# UNITED STATES PATENT AND TRADEMARK OFFICE

APPLICATION NO.	FILING DATE	FIRST NAMED INVENTOR	ATTORNEY DOCKET NO.	CONFIRMATION NO.
10/088,114	07/18/2002	Hiroshi Inoue	NIP-275	8078

# Office Action Summary

**DETAILED ACTION**

**FIG. 13**

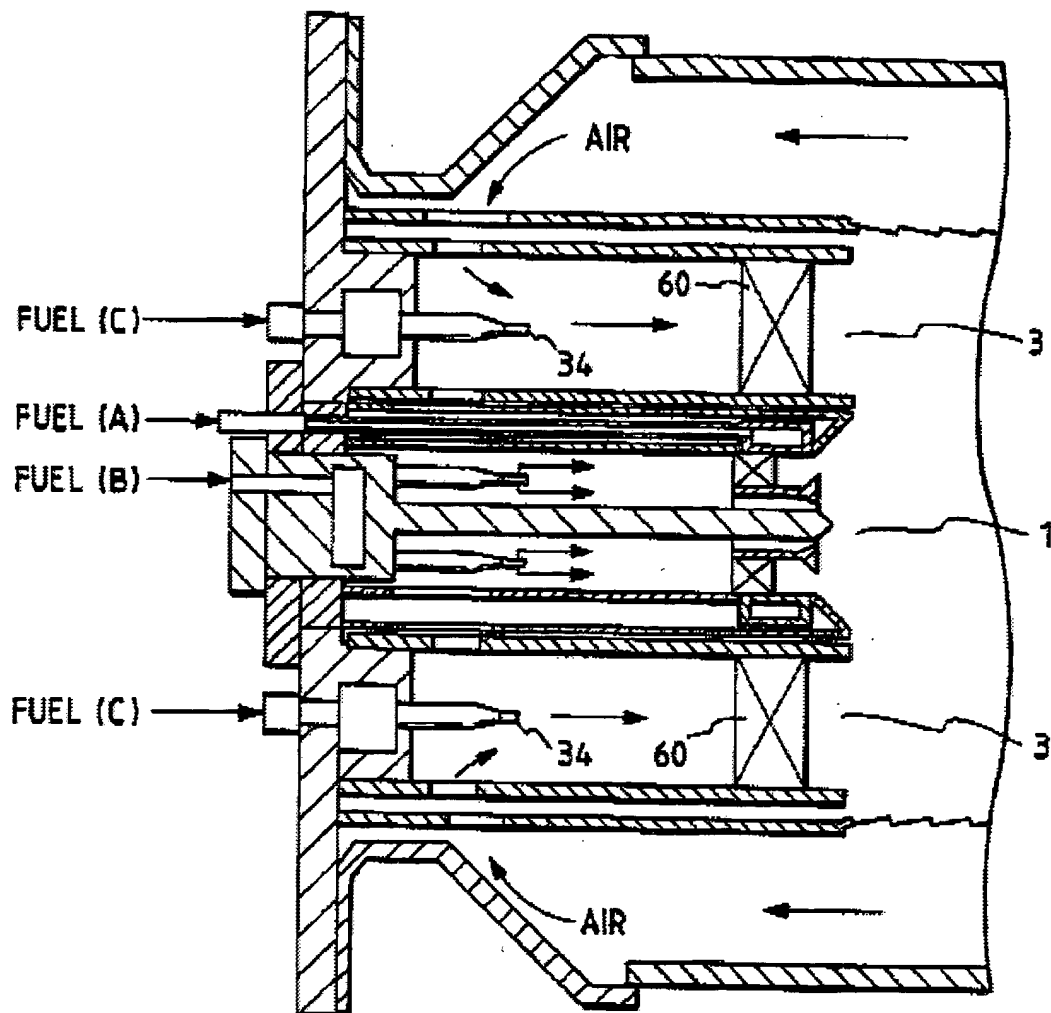
21. **Claims 1 & 7** are rejected under 35 U.S.C. 102(b) as being anticipated by (5,660,045) to Ito et al.

Ito et al., Figure 13 as displayed above discloses according to applicant's **claims 1 & 7**, a gas turbine combustor comprising diffusive combustion nozzles {inner ring of fuel B fed nozzles} which inject fuel and air into a combustion chamber and form a diffusive combustion flame, outer {next to air leader line connected to (60)} and inner {next to reference sign (34)} walls which form an annular premixing flow passage {framed by (60)} and premixing nozzles (34) which are disposed in the premixing flow passage and form a premixing combustion flame by injecting premixed gas formed by premixing fuel and air into the combustion chamber, characterized in that a plurality of the premixing nozzles (34) are arranged in the premixing flow passage {framed by (60)}; opening portions permitting air to flow in are provided at the outer wall {air vents connected to (60)} so that the air flowed into the premixing flow passage forms swirling flow with respect to the premixing nozzles (34); and the opening portions are disposed in circumferential direction and are provided one for every adjacent two premixing nozzles (34). See Ito et al., Figures 1-15, and respective portions, abstract, col. 11 lines 49-65 of the detailed description.

FIG. 4

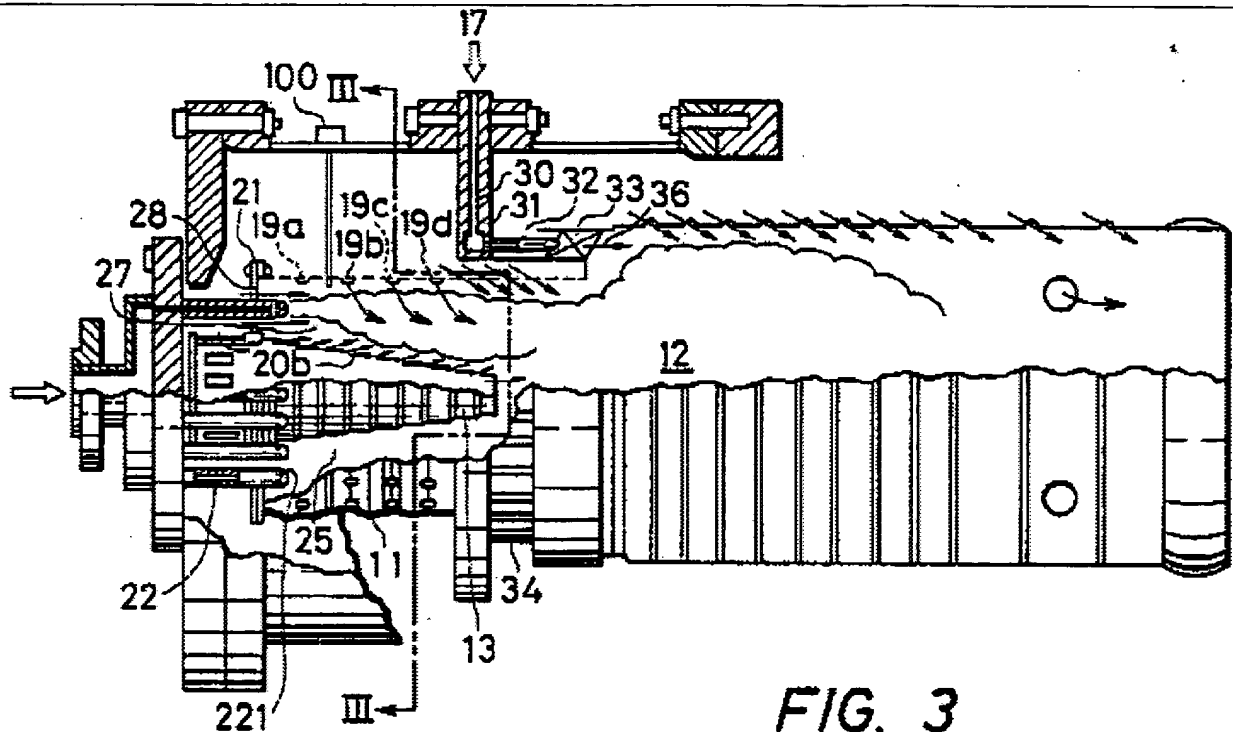
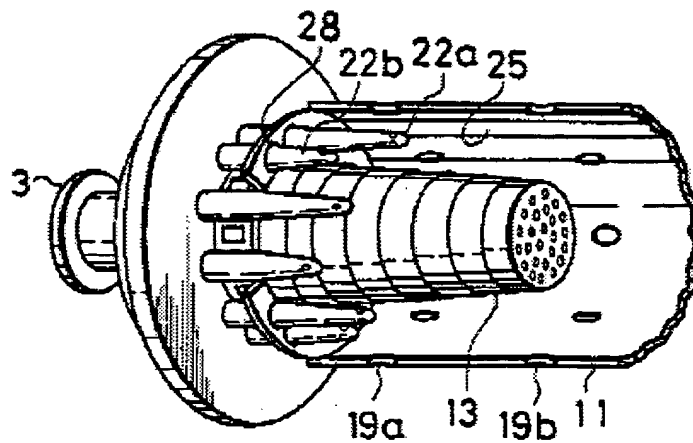
22. **Claims 1, 4 & 7** are rejected under 35 U.S.C. 102(b) as being anticipated by (4,898,001) to Kuroda et al.

Kuroda et al., Figures 3 & 4 as immediately displayed above discloses according to applicant's **claims 1, 4 & 7**, a gas turbine combustor comprising diffusive combustion nozzles {See Fig. 4, inner ring of fuel fed nozzles} which inject fuel and air into a combustion chamber (12) and form a diffusive combustion flame, outer {(12), (42b)} and inner {(11), (38)} walls which form an annular premixing flow passage {framed by (37), (42a), (42b)} and premixing nozzles (32) which are disposed in the premixing flow passage and form a premixing combustion flame by injecting premixed gas formed by premixing fuel and air into the combustion chamber (12), characterized in that a plurality of the premixing nozzles (32) are arranged in the premixing flow passage {framed by (37), (42a), (42b)}; opening portions {between (43a)-(43b) & between (12)-(43b)} permitting air to flow in are provided at the outer wall {between (43a)-(43b) & between (12)-(43b)} so that the air flowed into the premixing flow passage forms swirling flow with respect to the premixing nozzles (32); and the opening portions {circumferentially framed volume sections between (43a)-(43b) & between (12)-(43b) encompassing every two nozzles (32)} are disposed in circumferential direction and are provided one for every adjacent two

premixing nozzles (32). See Kuroda et al., Figures 2-7, and respective portions, abstract, col. 5 lines 15-68, col. 6 lines 1-40 and col. 11 lines 15-20 of the detailed description.

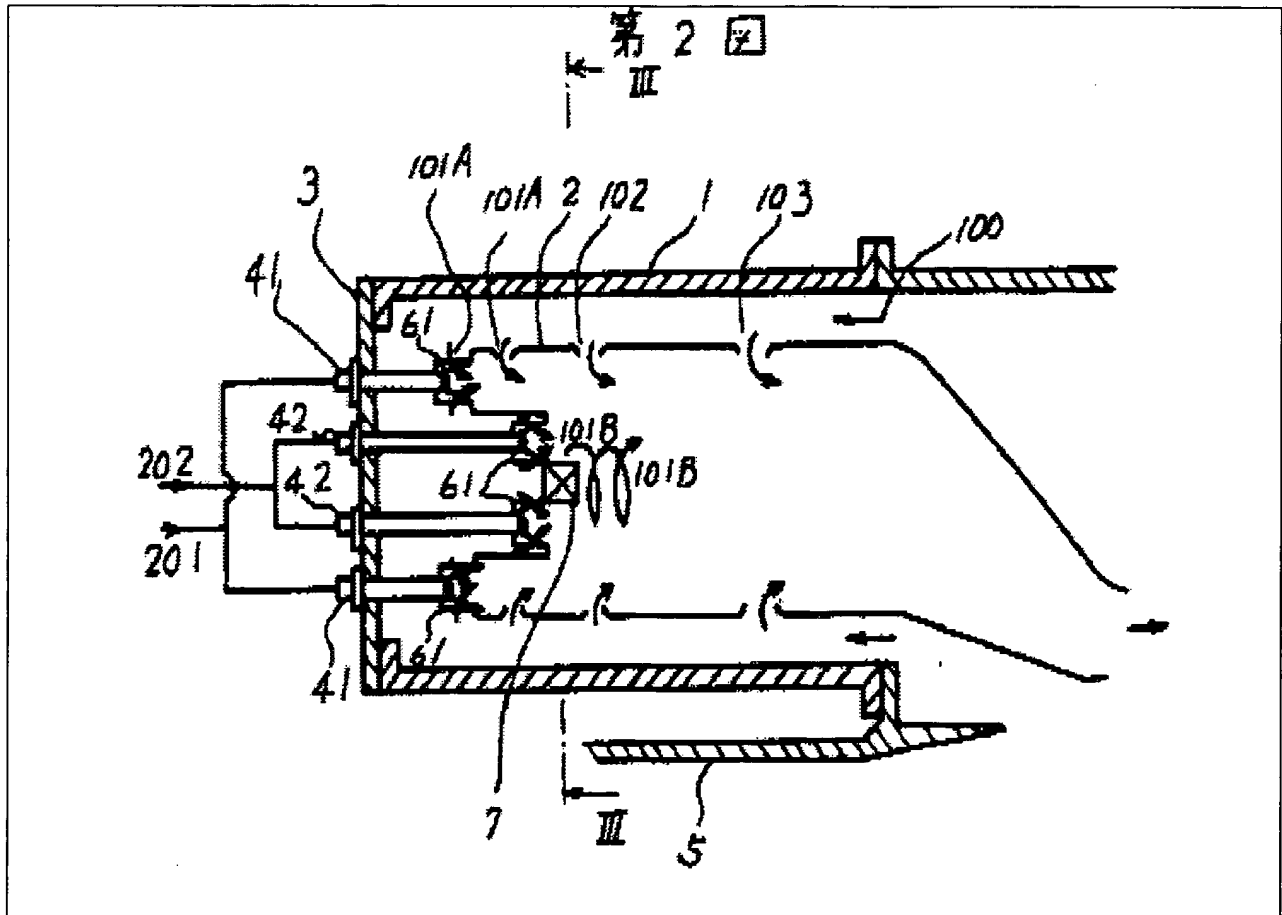
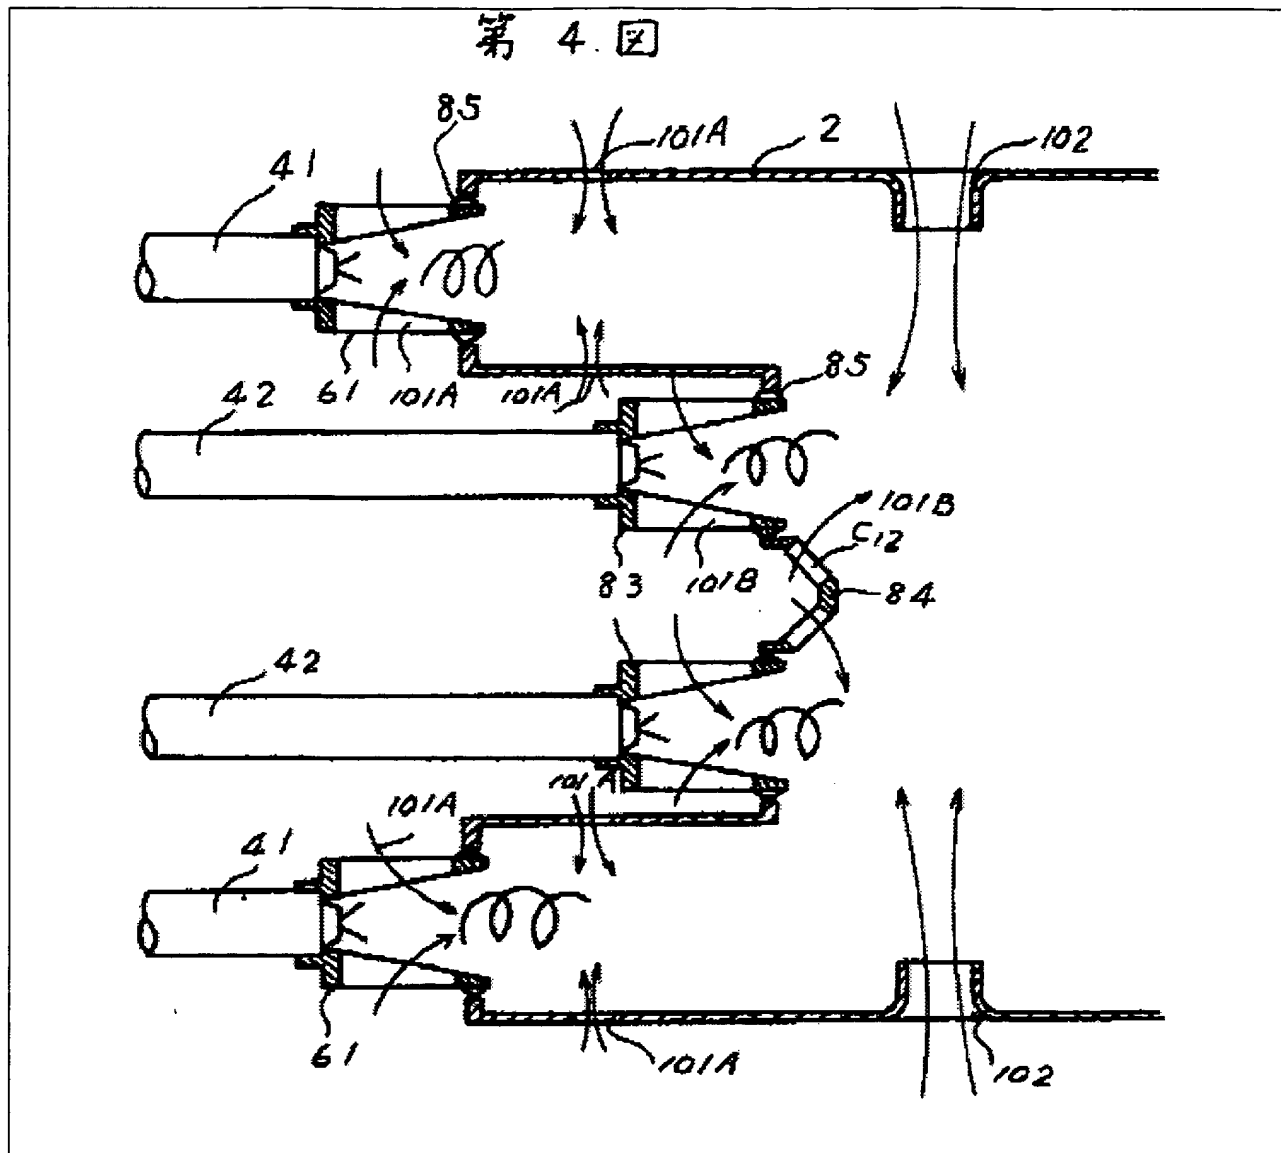
23. **Claims 1 & 7** are rejected under 35 U.S.C. 102(b) as being anticipated by (JP-355046309-A) to Kusaba et al.

Kuroda et al., Figures 2 & 4 as immediately displayed above discloses according to applicant's **claims 1 & 7**, a gas turbine combustor (1) comprising diffusive combustion nozzles {inner ring of fuel fed nozzles (42)} which inject fuel and air into a combustion chamber (2) and form a

diffusive combustion flame, outer {(2), (61)} and inner {containing (101A) next to (42)} walls which form an annular premixing flow passage {inline with (41)} and premixing nozzles (41) which are disposed in the premixing flow passage and form a premixing combustion flame by injecting premixed gas formed by premixing fuel and air into the combustion chamber (2), characterized in that a plurality of the premixing nozzles (41) are arranged in the premixing flow passage {inline with (41)} opening portions (101A) permitting air to flow in are provided at the outer wall {(2), (61)} so that the air flowed into the premixing flow passage forms swirling flow with respect to the premixing nozzles (41); and the opening portions {(101A) encompassing every two nozzles (41)} are disposed in circumferential direction and are provided {at least} one for every adjacent two premixing nozzles (41). See Kusaba et al., Figures 2 & n4 and English abstract.

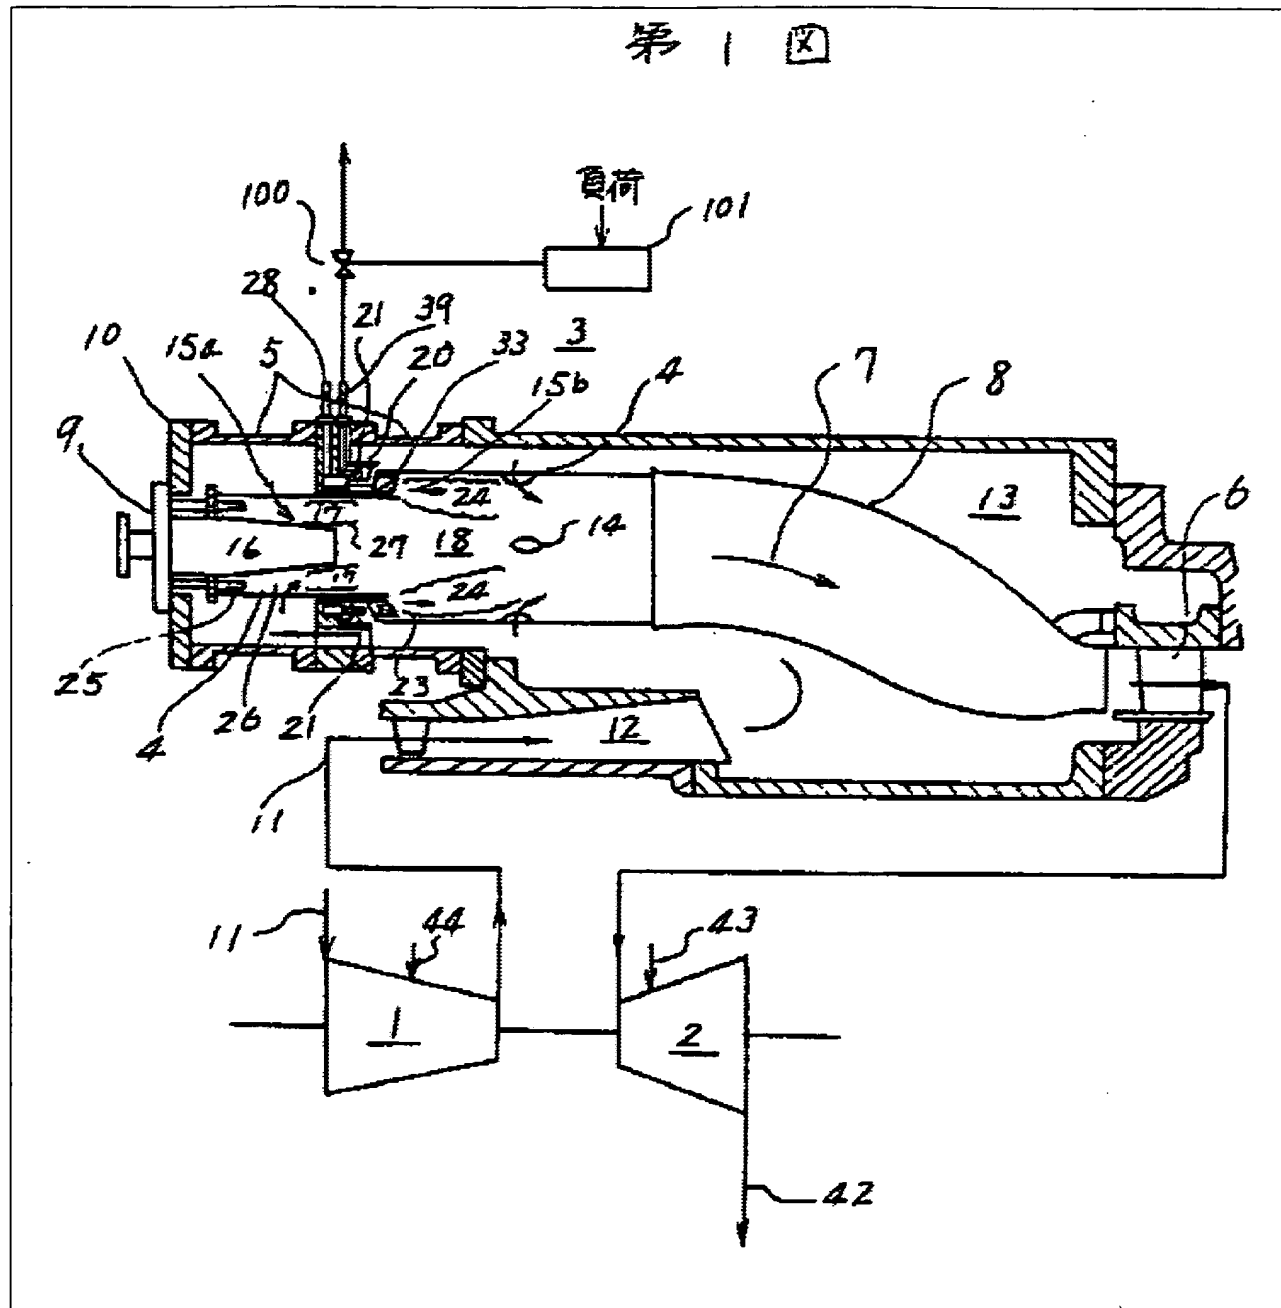
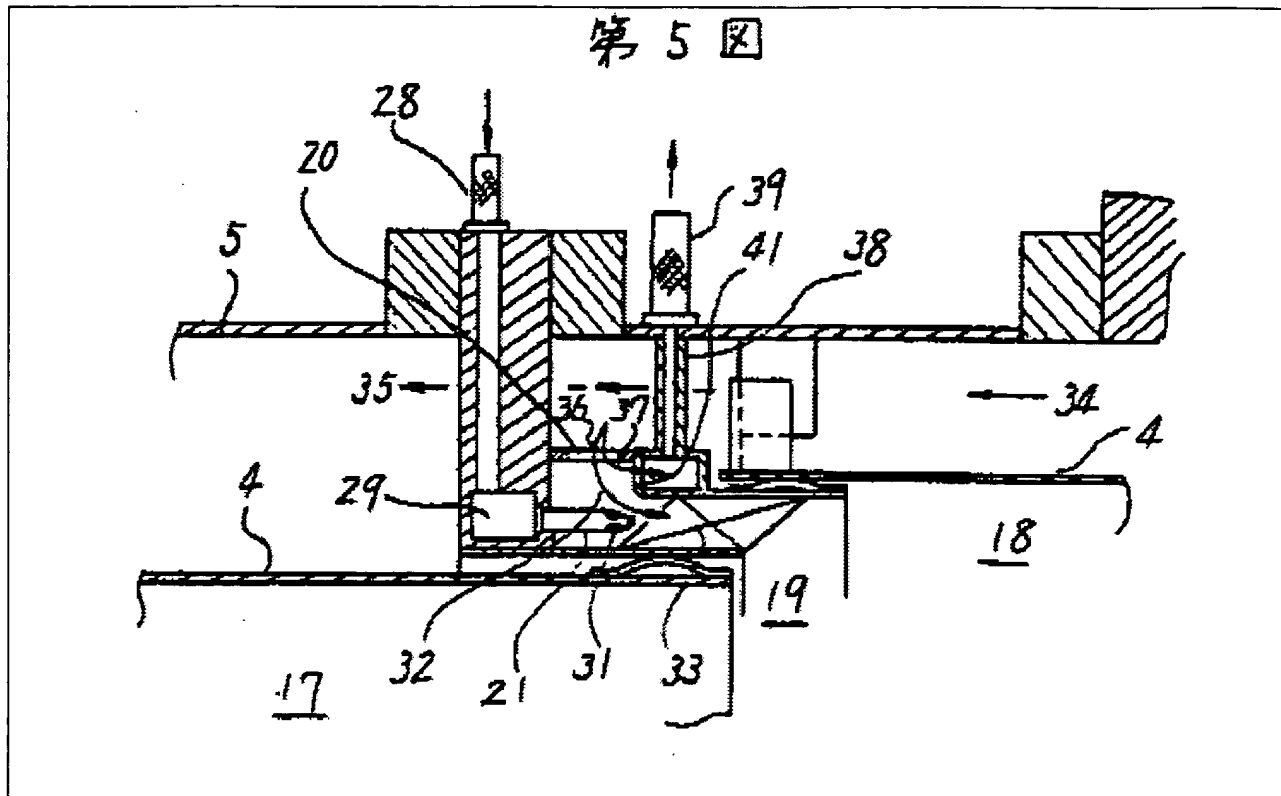
24. **Claims 1, 4 & 7** are rejected under 35 U.S.C. 102(b) as being anticipated by (JP-362175524-A) to Iizuka et al.

Iizuka et al., Figures 2 & 4 as immediately displayed above discloses according to applicant's **claims 1, 4 & 7**, a gas turbine combustor (4) comprising diffusive combustion nozzles {inner ring of fuel fed nozzles (25)} which inject fuel and air into a combustion chamber (4) and form a diffusive combustion flame, outer and inner walls {framed by (4)} which form an annular premixing flow passage {inline with (21)} and premixing nozzles (21) which are disposed in the premixing flow passage and form a premixing combustion flame by injecting premixed gas formed by

premixing fuel and air into the combustion chamber {(4), (18)},  
characterized in that a plurality of the premixing nozzles (21) are arranged  
in the premixing flow passage {inline with (21)} opening portions (20)  
permitting air to flow in are provided at the outer wall (37) so that the air  
flowed into the premixing flow passage forms swirling flow with respect to  
the premixing nozzles (21); and the opening portions (20) are disposed in  
circumferential direction and are provided {at least} one for every adjacent  
two premixing nozzles (21). See Iizuka et al., and English abstract.

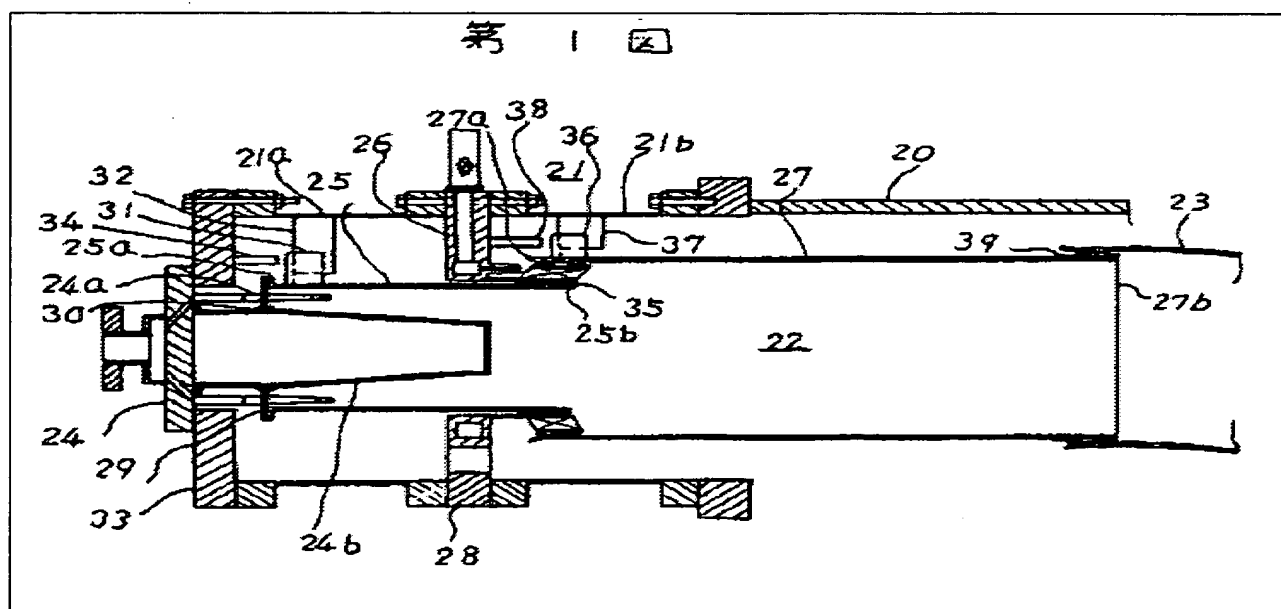
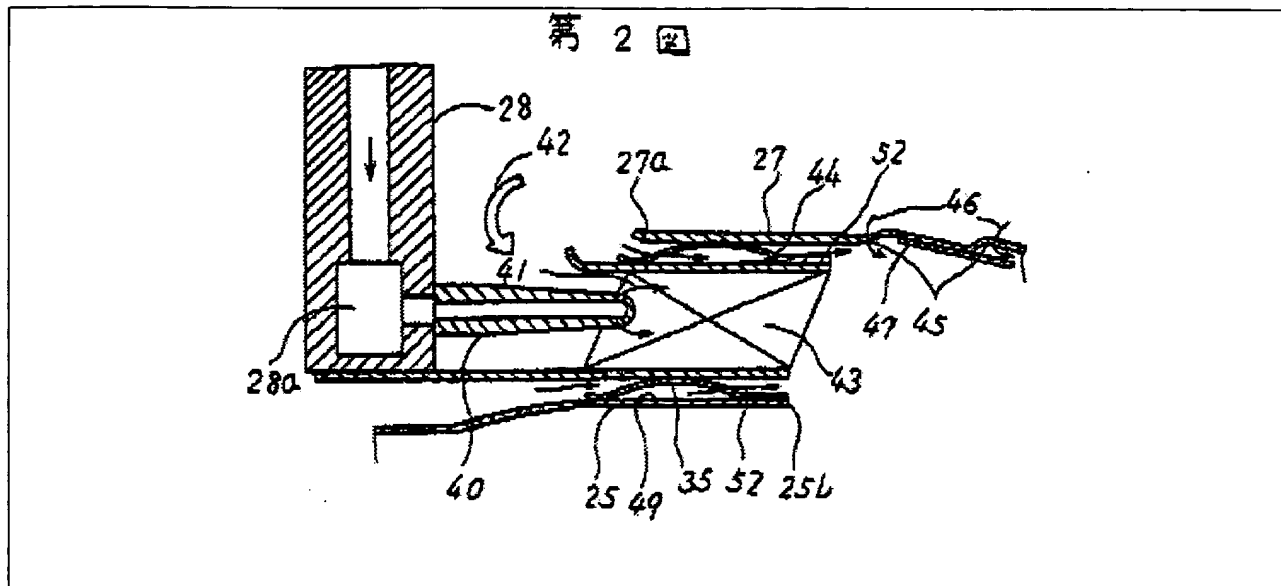
25. **Claims 1-3, 7, 9, 10 & 12-17** are rejected under 35 U.S.C. 102(b) as  
being anticipated by (JP-361119920-A) to Iizuka et al.

Iizuka et al., Figures 2 & 4 as immediately displayed above discloses according to applicant's **claims 1-3, 7, 9, 10 & 12-17**, a gas turbine combustor (22) comprising diffusive combustion nozzles {inner ring of fuel fed nozzles (24a)} which inject fuel and air into a combustion chamber (22) and form a diffusive combustion flame, outer and inner walls {framed by member (27)-(49) & means for swirling (43)} which form an annular premixing flow passage {inline with (40)} and premixing nozzles (40) which are disposed in the premixing flow passage and form a premixing combustion flame by injecting premixed gas formed by premixing fuel and air into the combustion chamber (22) characterized in that a plurality of the

premixing nozzles (40) are arranged in the premixing flow passage {inline with (40)} opening portions {between (27) & (43), between (49) & (43) and at (41)} permitting air to flow in are provided at the outer wall(s) {(27), (49) and framed by (43)} so that the air flowed into the premixing flow passage forms swirling flow with respect to the premixing nozzles (40); and the opening portions {circumferentially framed volume sections between (27) & (43), between (49) & (43) and at (41) encompassing every two nozzles (40)} are disposed in circumferential direction and are provided {at least} one for every adjacent two premixing nozzles (40) wherein the swirling flows at (41) can rotate in directions opposite each other in the circumferential direction {especially during turbine gas flow transients like as during faulty starts or shutdowns} for every adjacent two premixing nozzles (40). See Iizuka et al., Figures 1 & 2, and English abstract.
